Nye County

**Nye County Comments on NUREG-1768, Package Performance Study Test
Protocols, Draft Report for Comment**

NYE COUNTY COMMENTS ON PACKAGE PERFORMANCE STUDY TEST PROTOCOLS

NUREG-1768 DRAFT REPORT FOR COMMENT

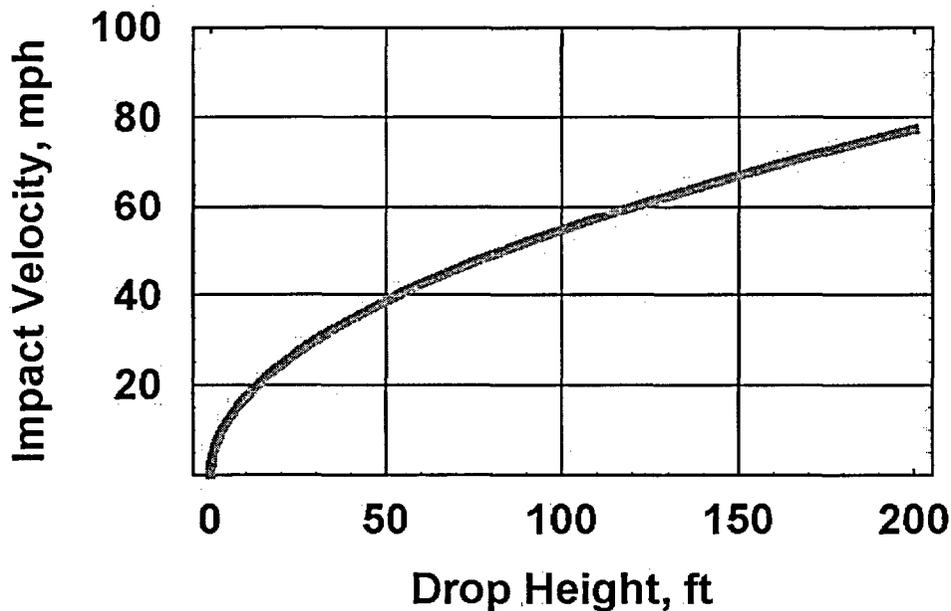
The tests should be conducted horizontally. If conducted as drops from a tower, however, the Test Protocols should be revised to clearly indicate that the test will be conducted from a height greater than 9 m (30 ft), and should indeed disclose the actual height of the drops proposed.

NUREG -1768, at p. 1, cites the current cask certification requirement for a 9 meter (approximately 30 ft) drop onto an unyielding surface, but does not at the same time make clear that such a drop is not proposed (or is

considered inadequate) for the PPS. Later, at p. 9, the document says that a "new drop tower might be high enough to allow an 82.3 m (270 ft.) free drop of a 136,000 kg (300,000 test unit--)." This is heartening, but it should be made very clear in the NUREG itself that the test will be conducted at a height greater than 30 feet. If a 270 foot tower is to be constructed than why not say at the outset that the drop will be from 270 feet? Clearly, a 30 foot drop test will not produce adequate results, because it does not simulate a worst case scenario at highway or rail speeds. Such a test would yield an impact velocity of approximately 30 mph, well below highway speeds.

We provide a simple example. A truck is traveling down the highway and hits an icy spot in the road. The driver loses control because of a driving error by the driver of the vehicle that is passing him/her at the time. The truck jackknifes and flips. The cask impacts directly on a bridge abutment or rock outcrop along the highway. The load on the cask may not be evenly distributed (point load), the mass of the truck trailer behind the cask may increase the impact forces, and the impact velocity may exceed the impact velocity from the 30 foot drop test. The relationship between height in the drop test and impact velocity (ignoring air resistance) is illustrated in the figure below.

The NUREG itself should provide no opportunity for any confusion on this. It should very explicitly state that the current cask certification requirement of a 9 m or 30 ft drop will not be employed, and should set out specifically the height to be used.
